Steeple Renewables Project

Flood Risk Assessment

Document Reference: EN010163/APP/5.3

Project No.: 680819-R5(02)-FRA
Site: Steeple Renewables Project
Title: Flood Risk Assessment
Client: Steeple Solar Farm Limited
Date: 30th April 2025
Office: Hemel Hempstead
Status: Final

Figure 5.1: Environment Agency ‘Flood map for planning’

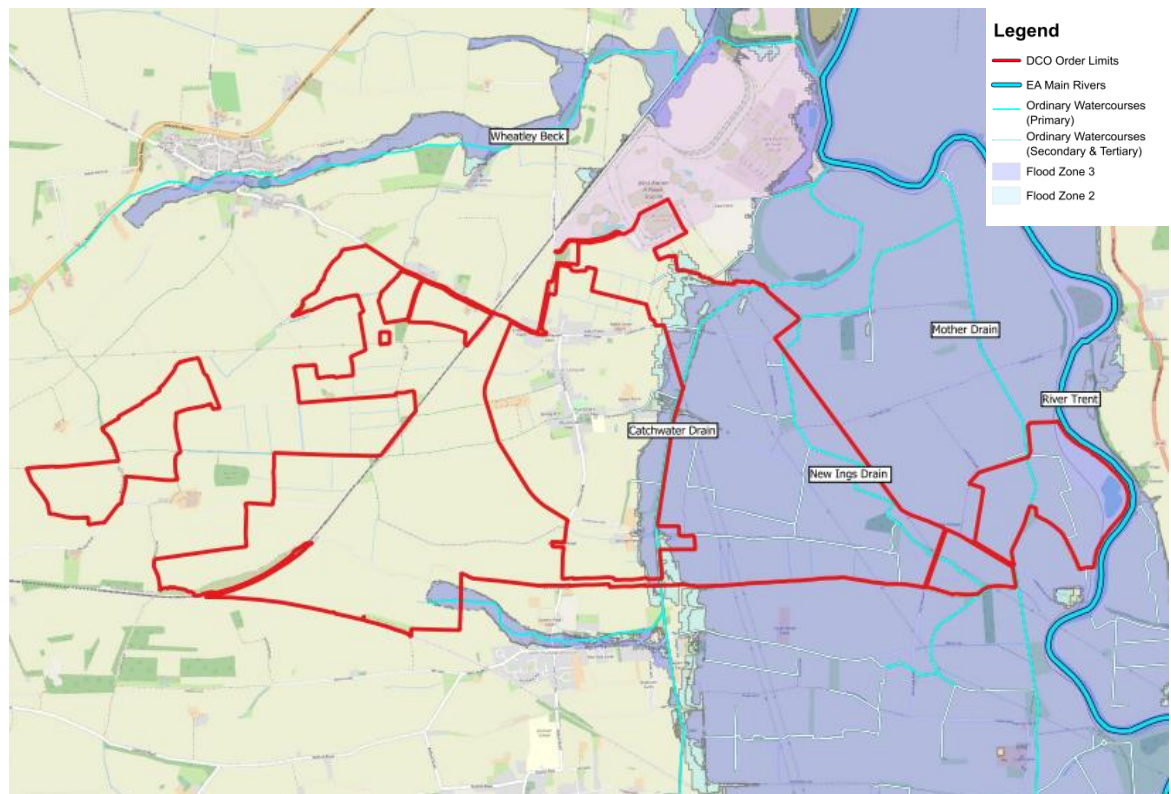
Issue	This section references the Environment Agency Flood Zone mapping. A plan is shown in figure 5.1 showing the Flood Map for Planning with regards to the order limits for the development. Please note, the Flood Map for Planning was updated on the 25 th of March 2025.
Impact	The assessment of flood risk could be inaccurate and outdated.
Solution	Please assess the latest updated Flood Map for Planning published on the 25 th March 2025 and distinguish between Flood Zone 3a and 3b.

Figure 1: Maximum calculated stage at the cross sections shown on page 205 of the FRA (Catchwater Drain 1) based on a peak flow for the 1% (1 in 100) plus 23% climate change scenario of 15.78m³/s. NOTE – channel capacity on the right bank is exceeded in the second cross section (B).

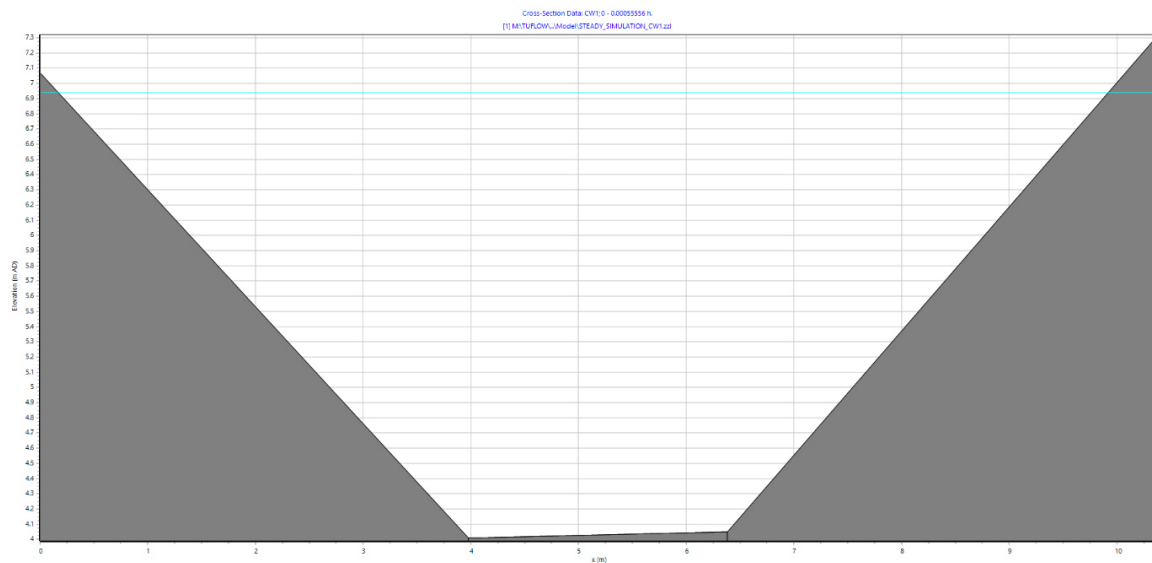
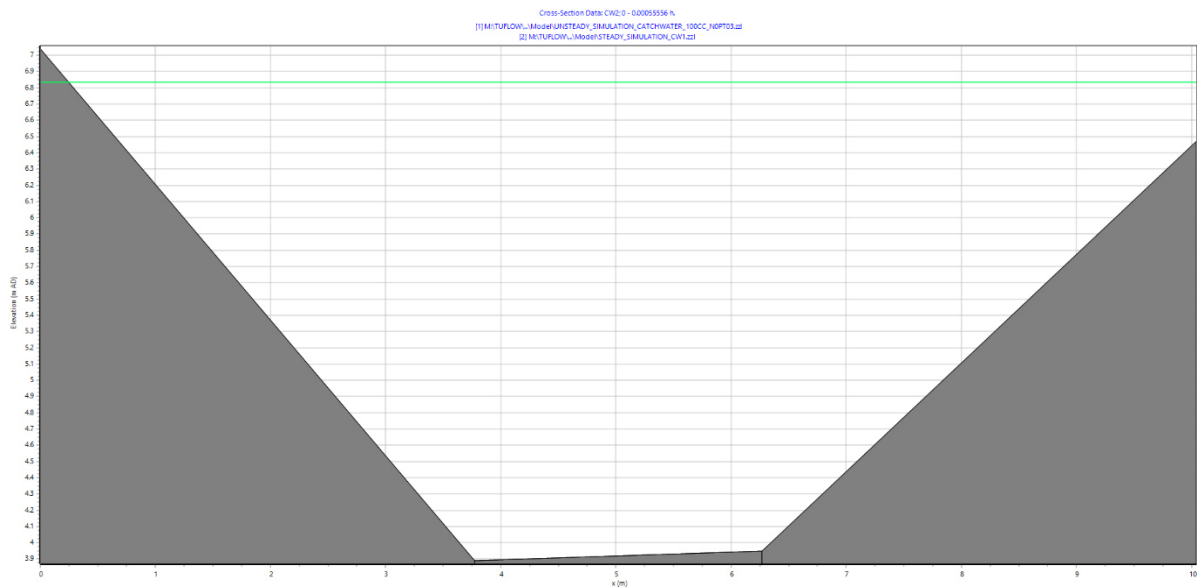
corroborated by adding the cross sections for Catchwater Drain 1 to Flood Modeller and running a steady state simulation with a peak flow of 15.78m³/s (figure 1)

Parameters for the cross section shown on page 205 with a left bank top elevation of 7.07 mAOD (see figure 1(a) below)

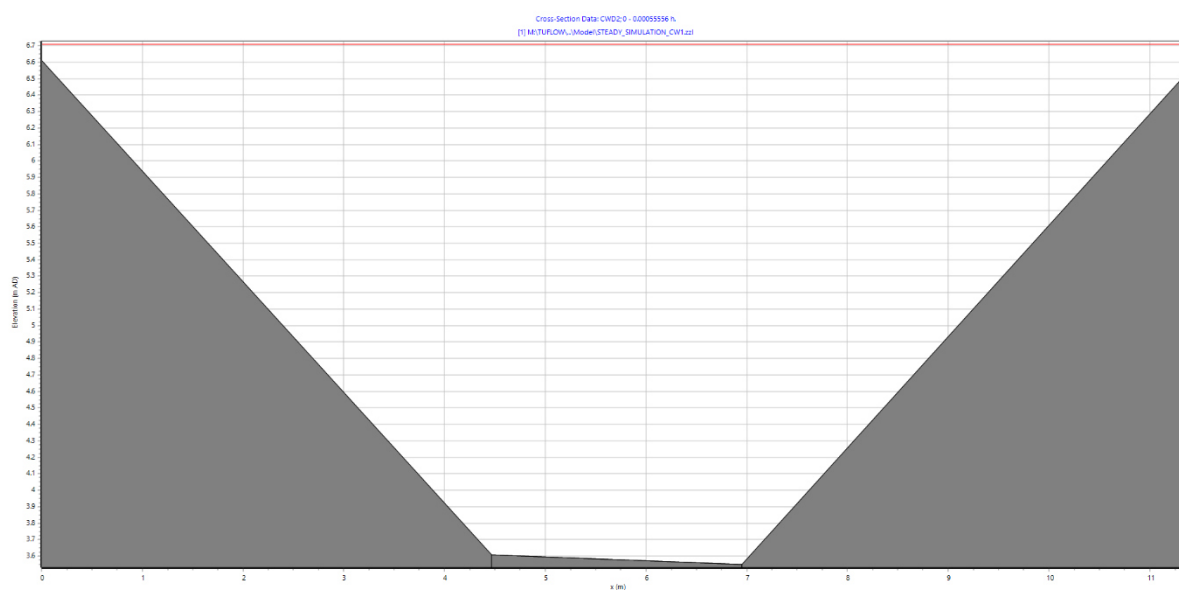
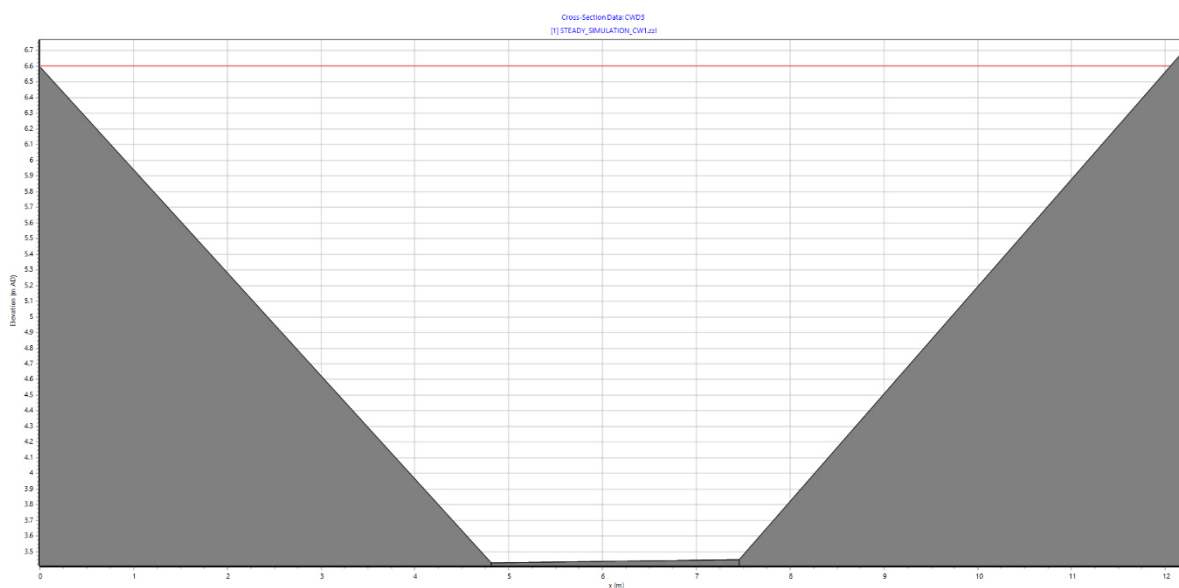
The Channel slope for Catchwater 2 appears to be overestimated. The calculated slope is shown in the screen shot on page 209 of the draft FRA as 0.029 metres per metre. Based on the cross sections presented on page 208 of the draft FRA and the distance between them, the slope would be more in the region of 0.00021 metres/metre. For example, 3.55 metres – 3.45 metres = 0.1 metres. $0.1\text{m}/478.36\text{m} = 0.000209\text{m/m}$. Considering this and the channel geometry and roughness, it is evident that the channel could overtop in the design event. For example, if we consider the Mannings equation for the second cross section shown on page 208 for Catchwater Drain 2, the calculated flow to top of bank is $15.73\text{m}^3/\text{s}$. Further details are shown in the calculations below. This is significantly less than the calculated carrying capacity of $176.29\text{m}^3/\text{s}$ quoted in the draft Flood Risk Assessment. This is further corroborated by adding the cross sections for Catchwater Drain 2 to Flood Modeller and running a steady state simulation with a peak flow of $15.78\text{m}^3/\text{s}$ (figure 2)

Parameters for the cross section shown on page 208 with a left bank top elevation of 6.6 mAOD (see figure 2(a) below)

Figure 3: Maximum calculated stage at the cross sections shown on page 211 of the FRA (Catchwater Drain 3) based on a peak flow for the 1% (1 in 100) plus 23% climate change scenario of 15.78m³/s.

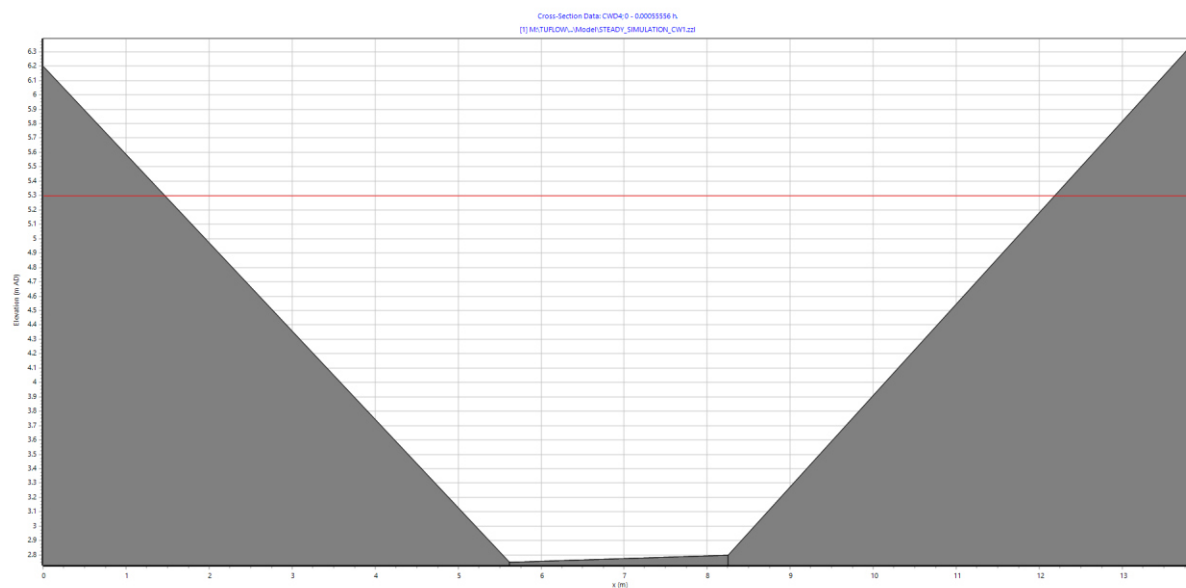
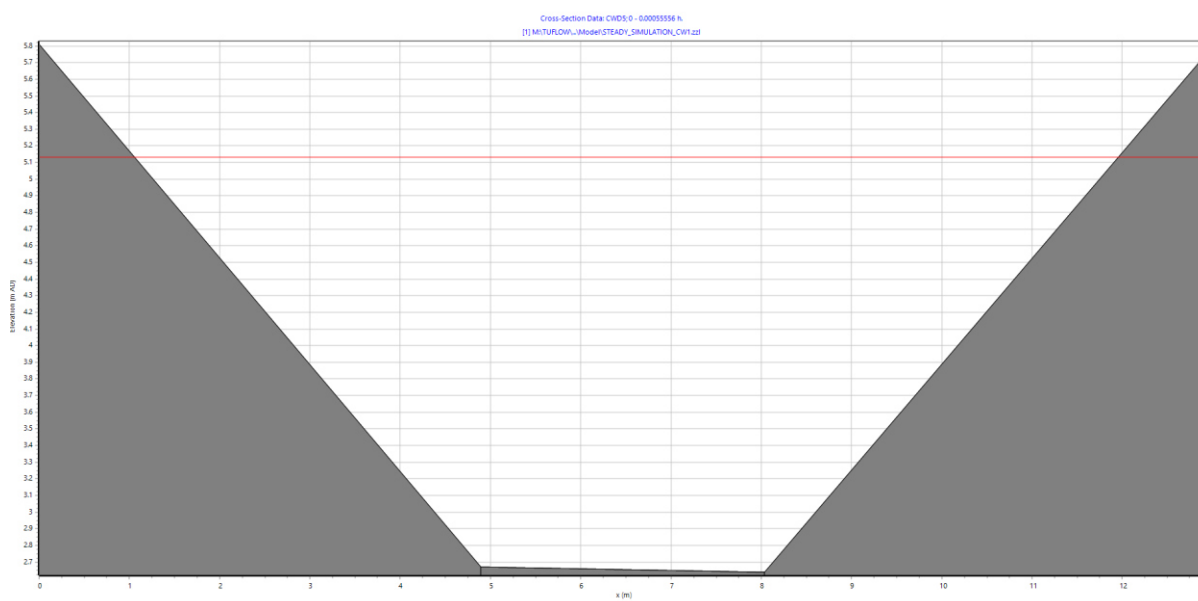
The channel slope for Catchwater 3 appears to be overestimated. The calculated slope is shown in the screen shot on page 212 of the draft FRA as 0.035 metres per metre. Based on the cross sections presented on page 211 of the draft FRA and the distance between them, the slope would be more in the region of 0.00047 metres/metre. For example, 2.8 metres – 2.64 metres = 0.16 metres. $0.16\text{m}/341.83\text{m} = 0.000468\text{m/m}$. Considering this and the channel geometry and roughness there may be capacity within the channel at this location to convey the design flood. For example, if we consider the Mannings equation for the second cross section shown on page 211 for Catchwater Drain 3, the calculated flow to top of bank is $26.53\text{m}^3/\text{s}$. Further details are shown in the calculations below. This suggests that the channel may have capacity to convey the design flow at this location. This is further corroborated by adding the cross sections for Catchwater Drain 3 to Flood Modeller and running a steady state simulation with a peak flow of $15.78\text{m}^3/\text{s}$ (figure 3)

Parameters for the cross section shown on page 211 with a left bank top elevation of 5.81 mAOD (see figure 3(a) below)

Figure 4: Maximum calculated stage at the cross sections shown on page 214 of the FRA (Mother Drain 1) based on a peak flow for the 1% (1 in 100) plus 23% climate change scenario of 5.38m³/s

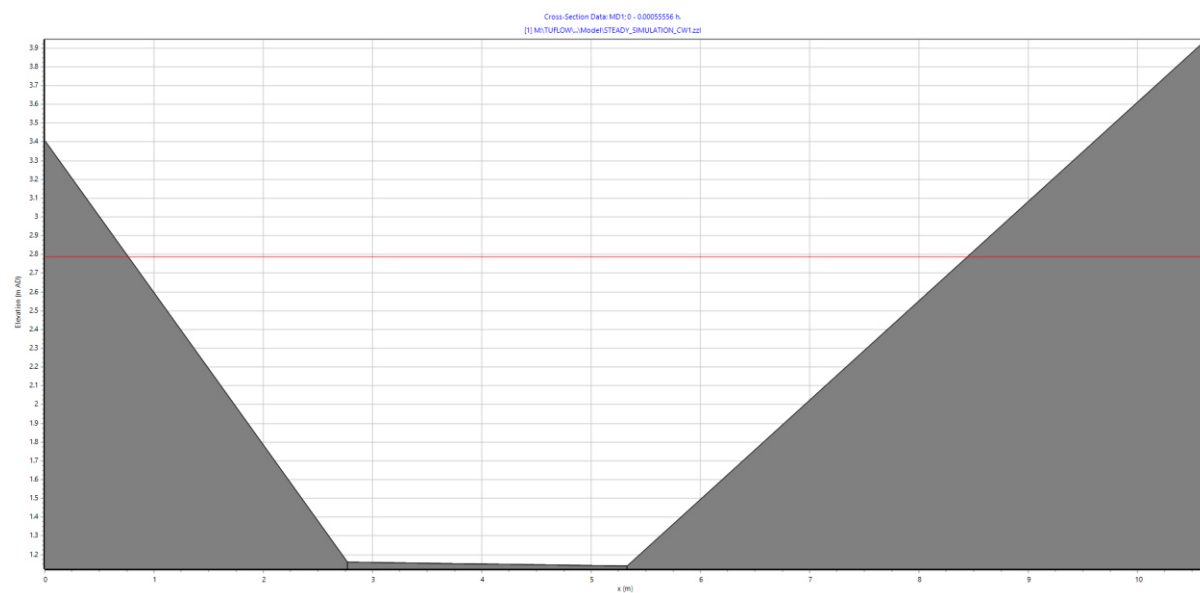
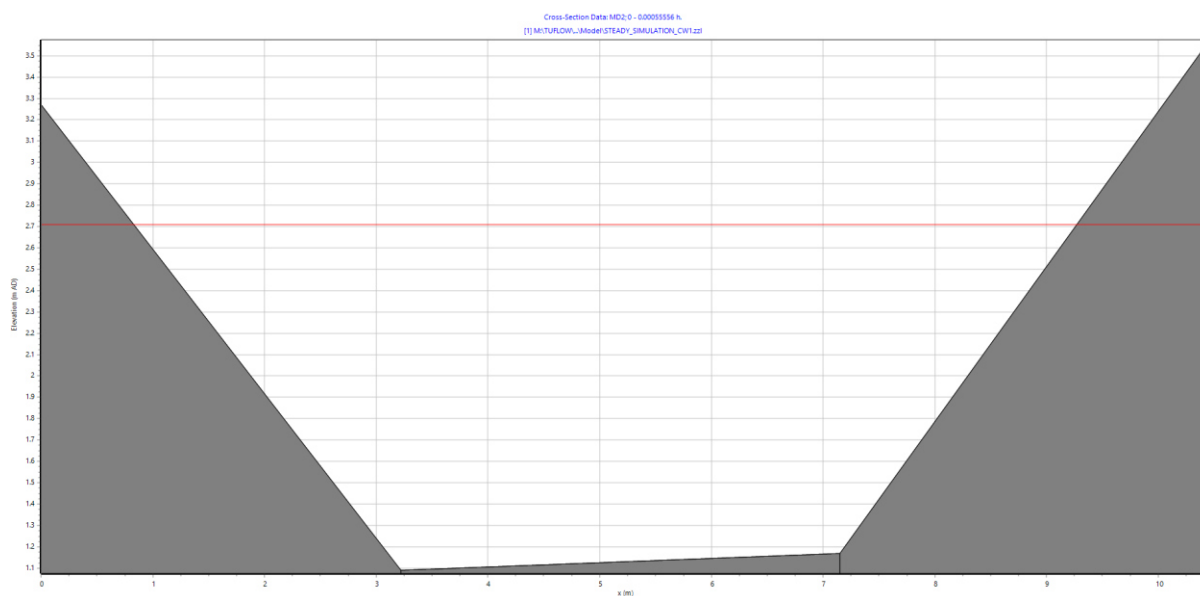
Parameters for the cross section shown on page 214 with a left bank top elevation of 3.27 mAOD (see figure 4(a) below)

Figure 5: Maximum calculated stage at the cross sections shown on page 220 of the FRA (New Ings Drain 1) based on a peak flow for the 1% (1 in 100) plus 23% climate change scenario of $4.48\text{m}^3/\text{s}$

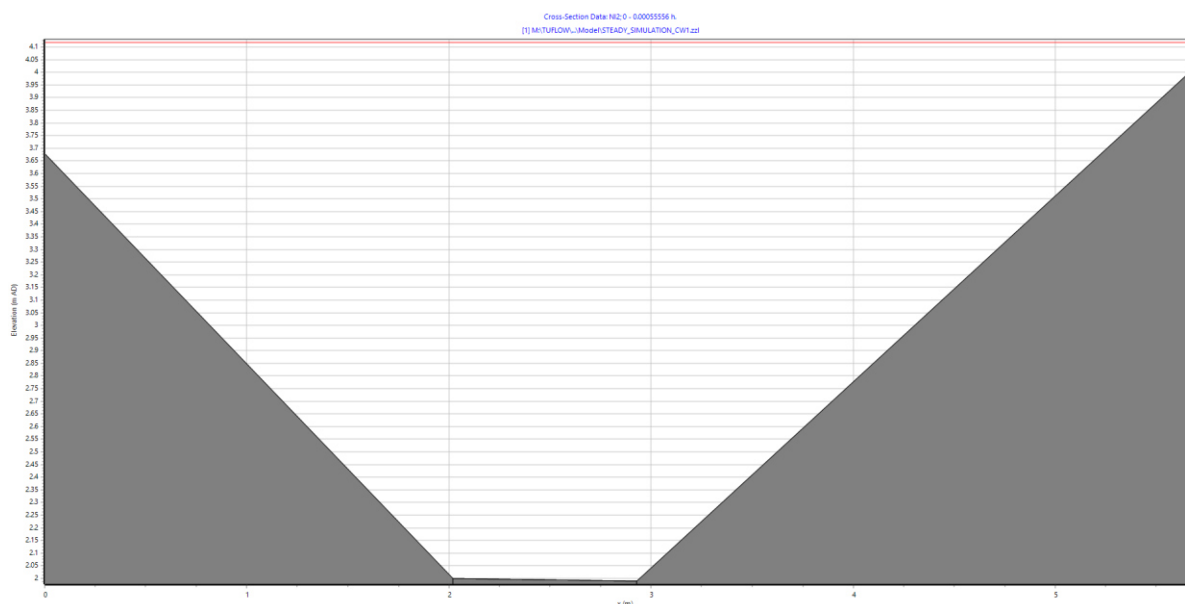
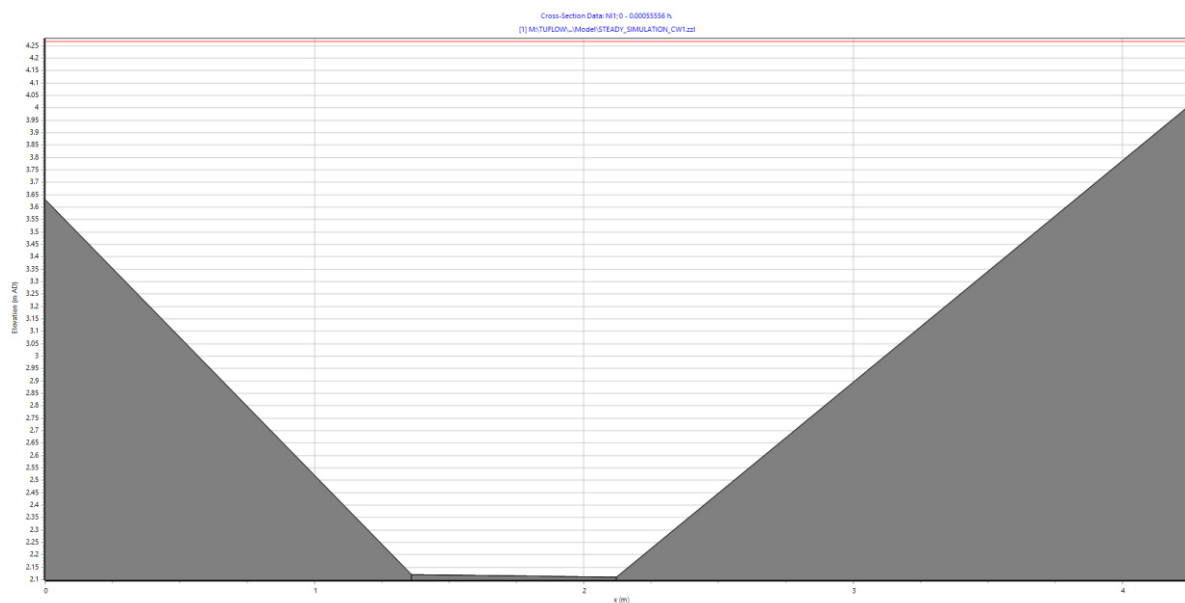
Parameters for the cross section shown on page 220 with a left bank top elevation of 3.27 mAOD (see figure 4(a) below)

Figure 6: Maximum calculated stage at the cross sections shown on page 223 of the FRA (New Ings Drain 2) based on a peak flow for the 1% (1 in 100) plus 23% climate change scenario of $4.48\text{m}^3/\text{s}$

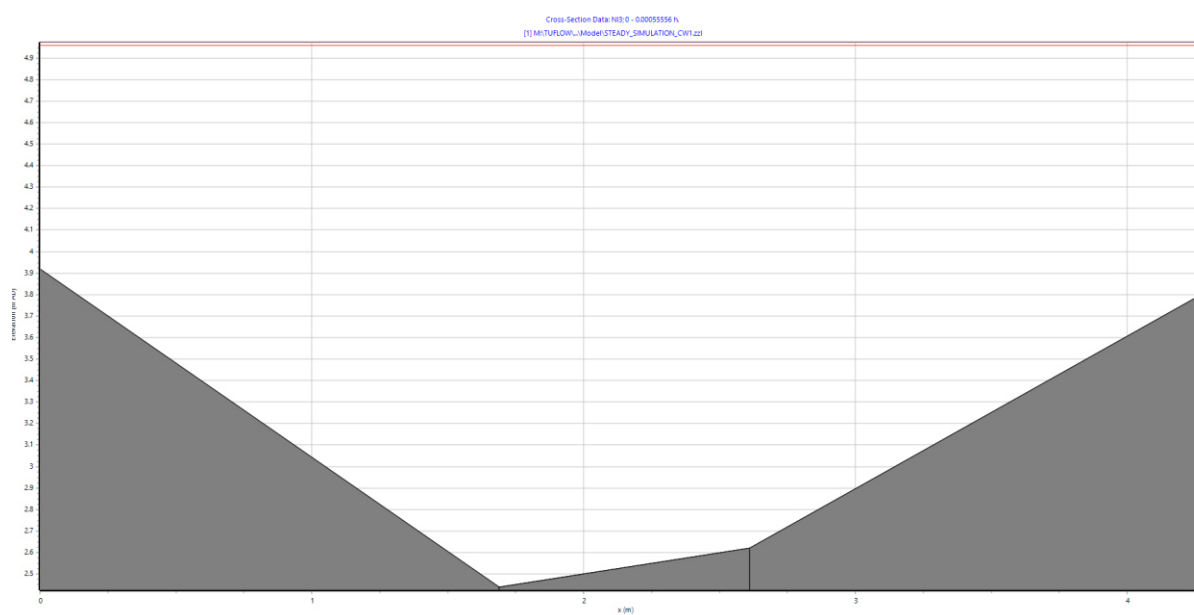
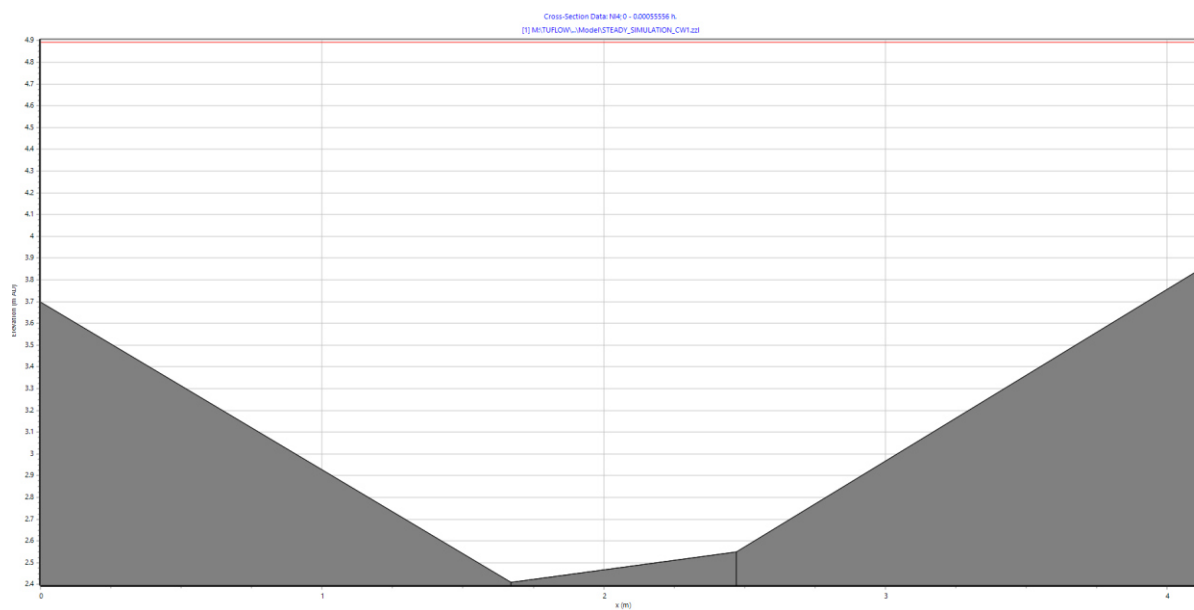
Parameters for the cross section shown on page 223 with a left bank top elevation of 3.27 mAOD (see figure 6(a) below)
